REFERENCE NO. 01/2012/1062
52 & 54 VALE STREET,
DENBIGH

ITEM NO: 1
WARD NO: Denbigh Central
APPLICATION NO: 01/2012/1062/ PF
PROPOSAL: Demolition of existing offices and erection of a new office building, relocation of vehicular access and associated works
LOCATION: 52 & 54 Vale Street Denbigh
APPLICANT: Cymdeithas Tai Clwyd
CONSTRAINTS: Town Heritage Area
 Conservation Area
PUBLICITY UNDERTAKEN: Site Notice - Yes
 Press Notice - Yes
 Neighbour letters - Yes

LAYOUT PLAN

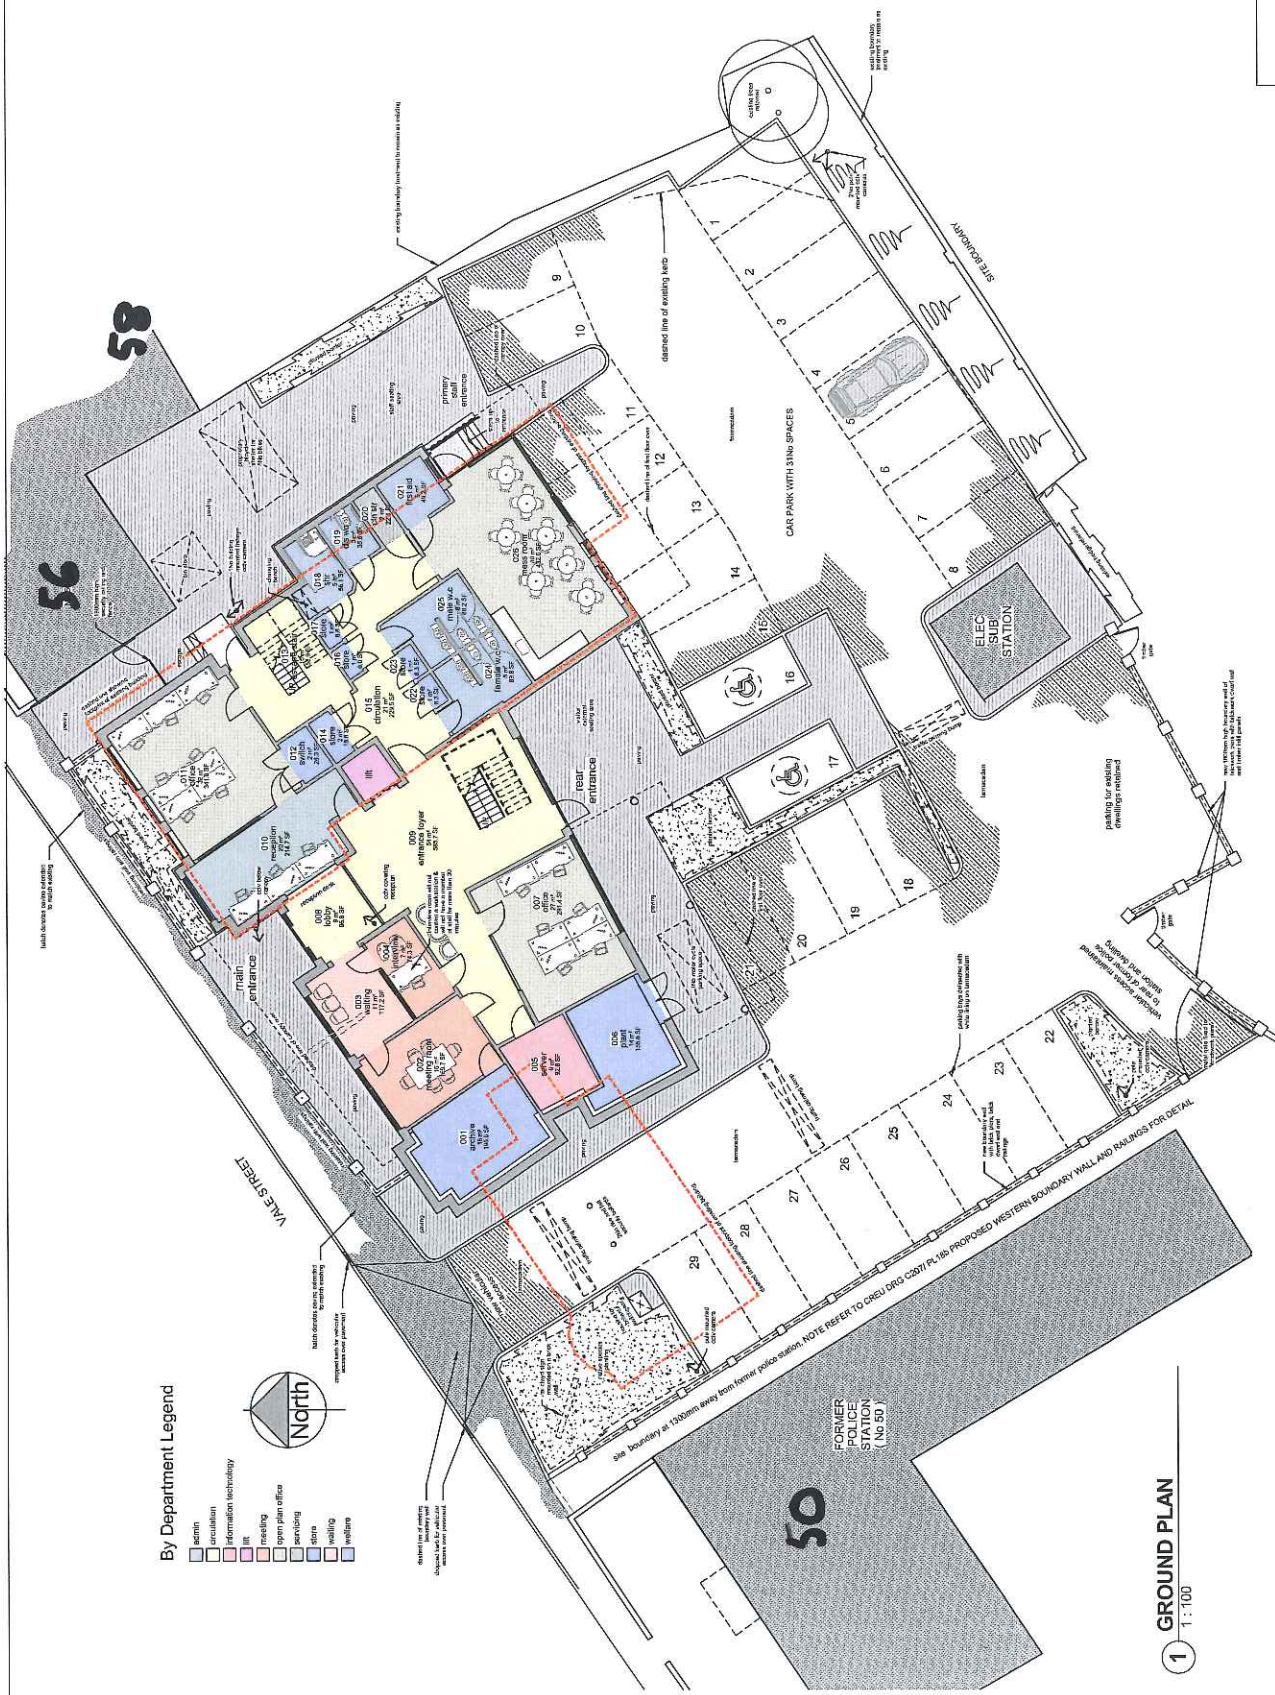
REV A 13 FEB 12 - scheme revised assuming the existing office will be demolished
 REV C 13 MAR 12 - layout revised to suit client comments
 REV D 02 APR 12 - revised during planning consultation
 REV E 13 NOV 12 - eastern elevation moved away from 54 vale street following discussions with planning. parking layout revised to suit. south eastern boundary line revised to accommodate the new building and No. 56. use and lot bounds added to vehicle entrance, vehicle turning area, block wall with top coping aprons added to the planning level. revised layout revised to suit in the north east of the site.
 PERMITTED USES: COMMERCIAL OFFICE, RETAIL AND GUEST ACCOMMODATION

VALE STREET FRONT ELEVATION

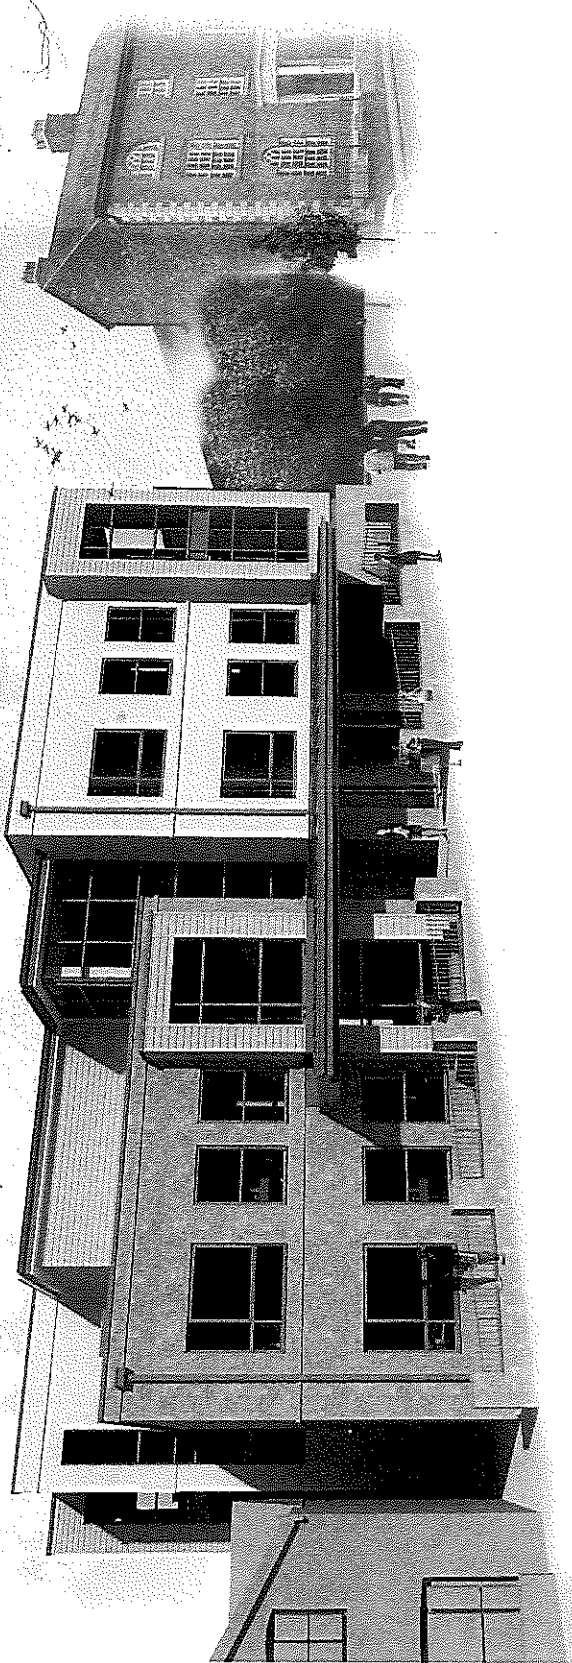
- Concerns were raised regarding the possible impact of the proposed new building on No. 56 Vale Street.
- Concerns were also raised regarding the visual impact the proposed front canopy would have on Vale Street.
- A question was asked- whether the applicants have approached and sought advice from the Design Commission".

Concerns raised over appropriateness of the scale of the proposed building relative to those adjoining and the design and detailing of the proposal.

Concerns raised over the design concept, it's impact of proposal on historic streetscape and the setting of No. 56 Vale Street.

The design of the building has raised a range of responses. Officers' opinion is that with respect to the concerns expressed, the modern approach to design would not be inappropriate given the variation in the scale and styles of development in the locality, and that to respect the concerns of the Conservation Architect, conditions should be considered to agree the final external materials. A redevelopment would remove what is currently an unremarkable building in the Conservation Area midway down Vale Street, and result in a modern redevelopment which would not be out of place in this location. The proposal is not considered to conflict with policies GEN 6, CON 5 and CON 7.
